ROCKY FLATS SITE REGULATORY CONTACT RECORD 2015-02

Purpose: Soil Disturbance Review Plan (SDRP) for Storage Shed Photovoltaic Upgrades

Contact Record Approval Date: April 25, 2015

Figure 1. Location of Excavation for Storage Shed PV Upgrades Project

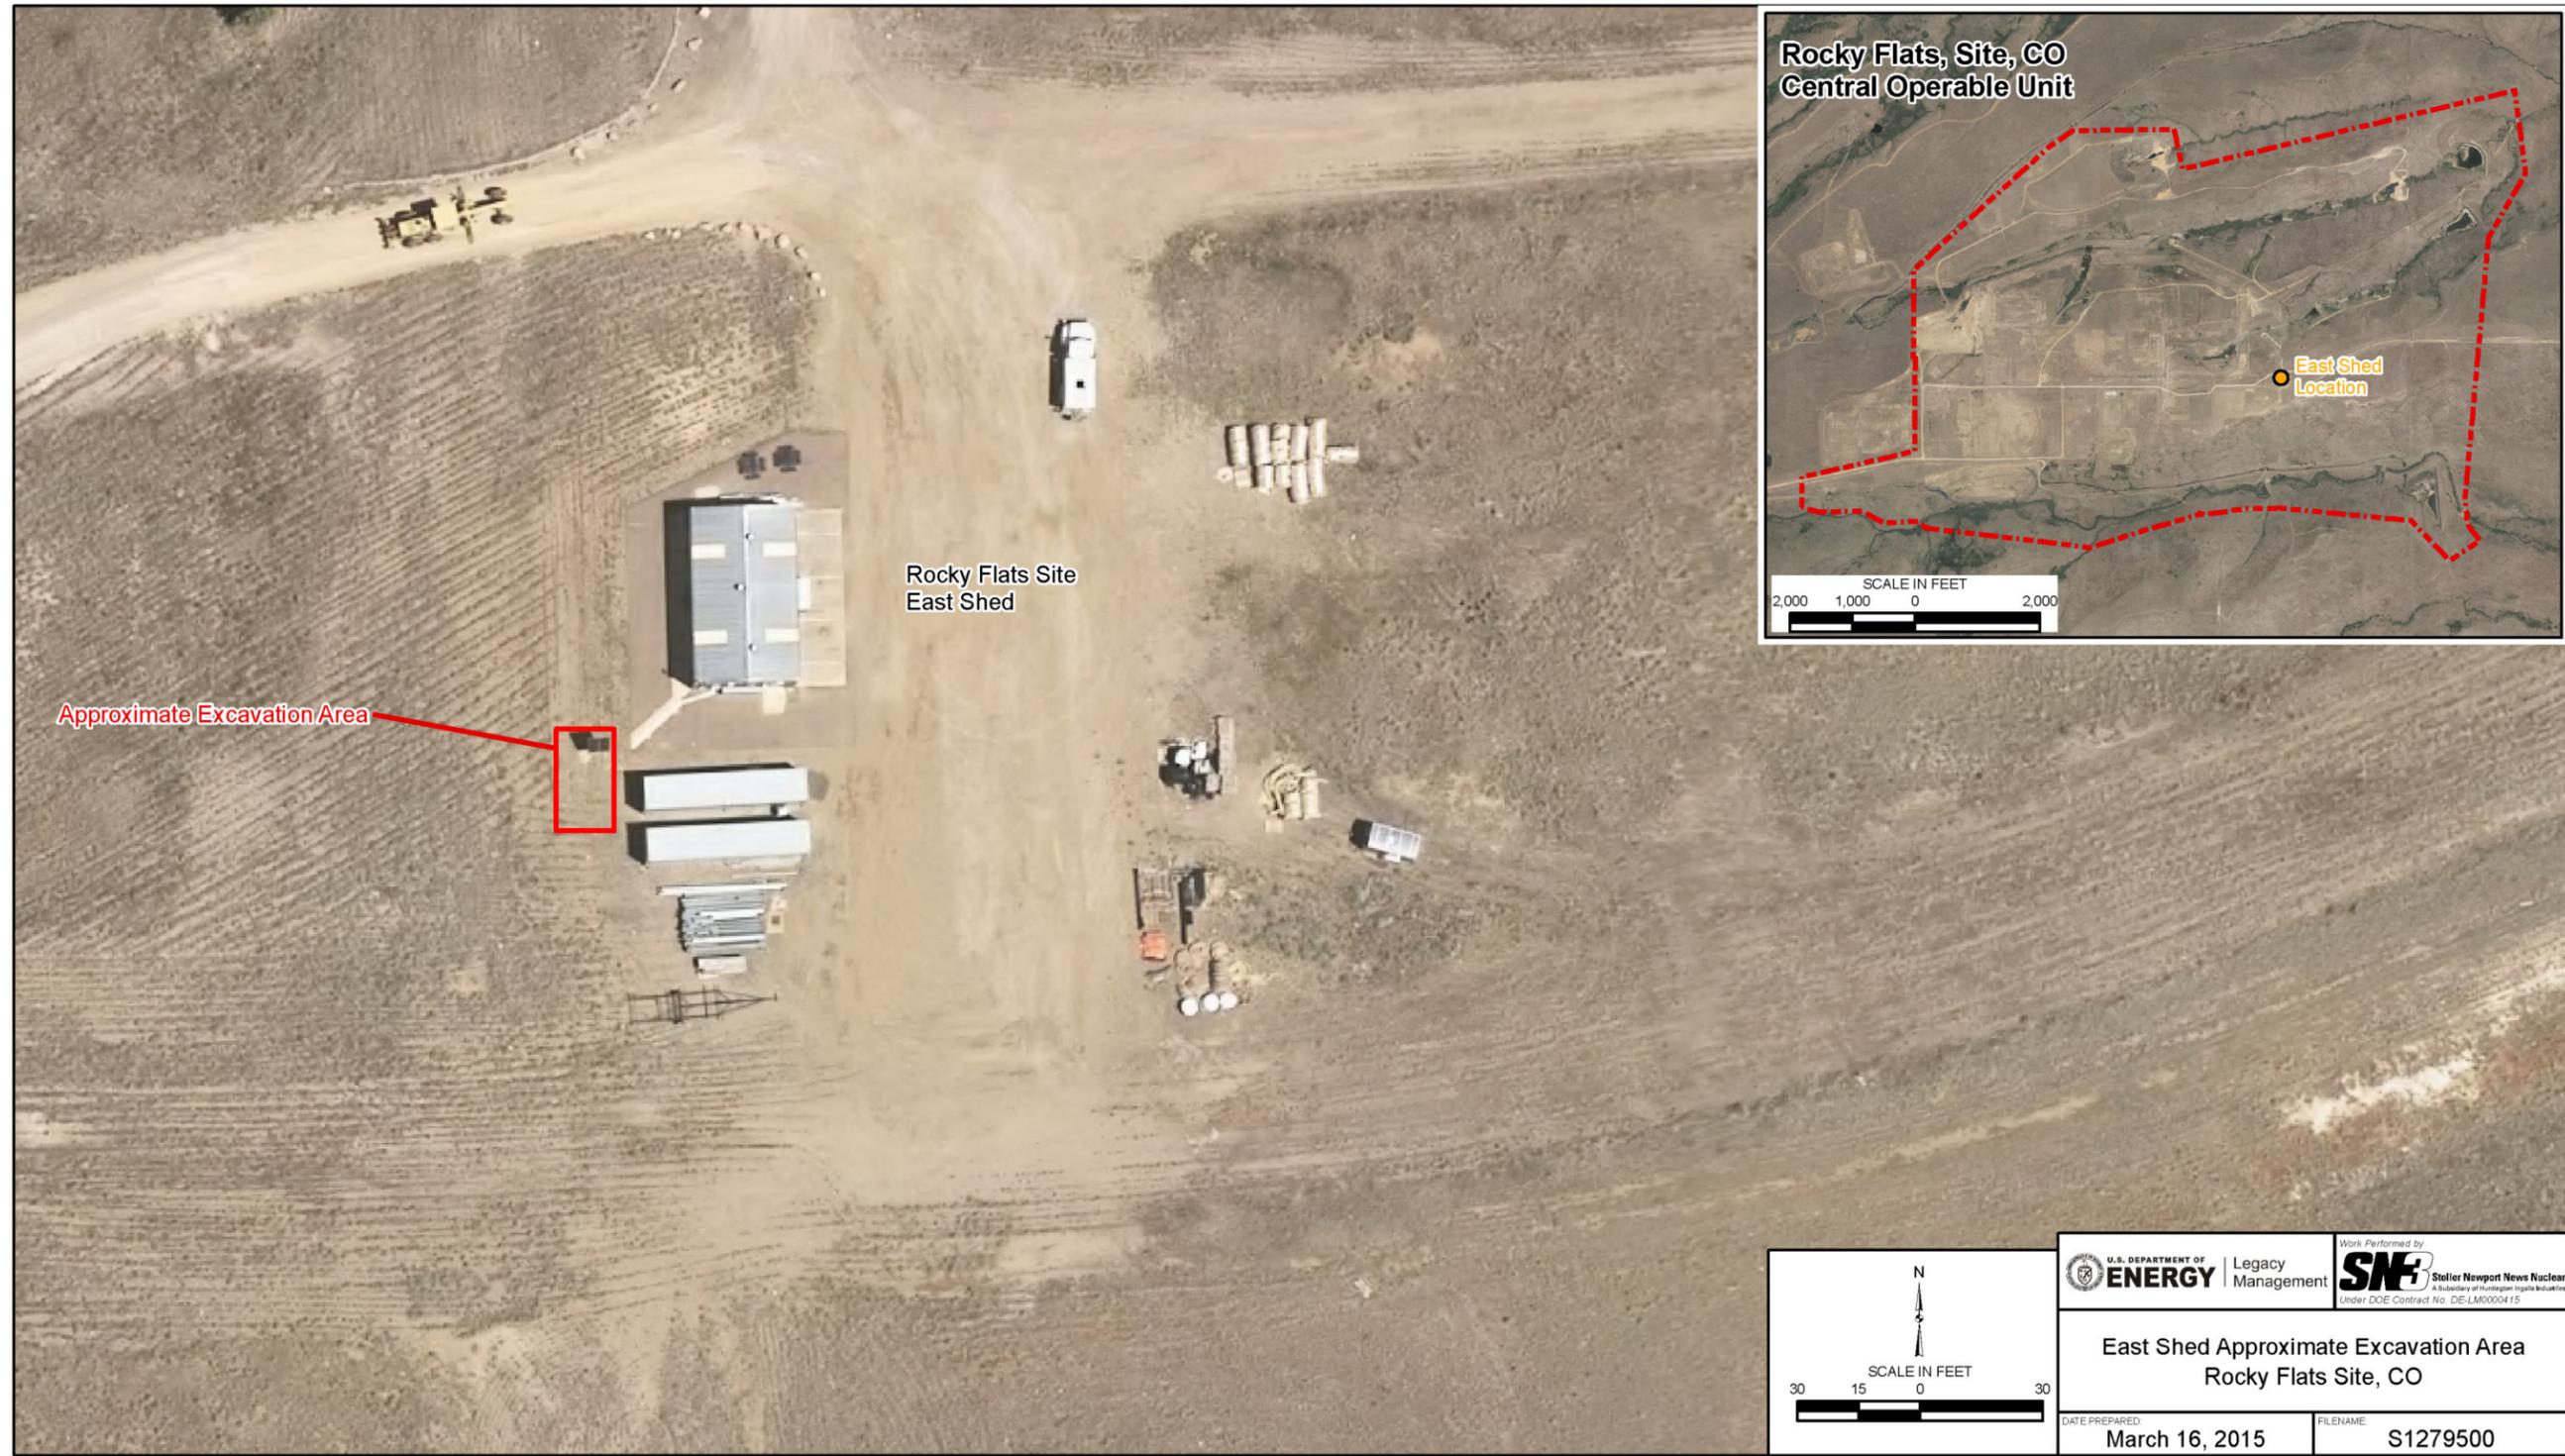
The soil disturbance that occurs during the excavation of the holes for the support of the new PV panels is subject to the requirements of certain *Rocky Flats Legacy Management Agreement* (RFLMA) institutional controls (ICs), as discussed below. An approved SDRP is required and the RFLMA parties agree that Figure 1 provides sufficient information for the SDRP for the proposed work.

Holes, 12-inches in diameter and approximately 3 feet deep, will be drilled and filled with concrete. The additional PV panels will be supported by the new concrete footings. Figure 1 in Contact Record 2015-02 shows the approximate location of the new supports.

Resolution: CDPHE has review information regarding the proposed soil disturbance and excavation and, after consulting with EPA, has approved the proposed activity and the proposed grading plan. CDPHE has determined that the proposed activity will not compromise or impair the function of the remedy or result in an unacceptable release or exposure to residual subsurface contamination. CDPHE has also determined that the proposed project meets the rationale and objectives of IC 2.
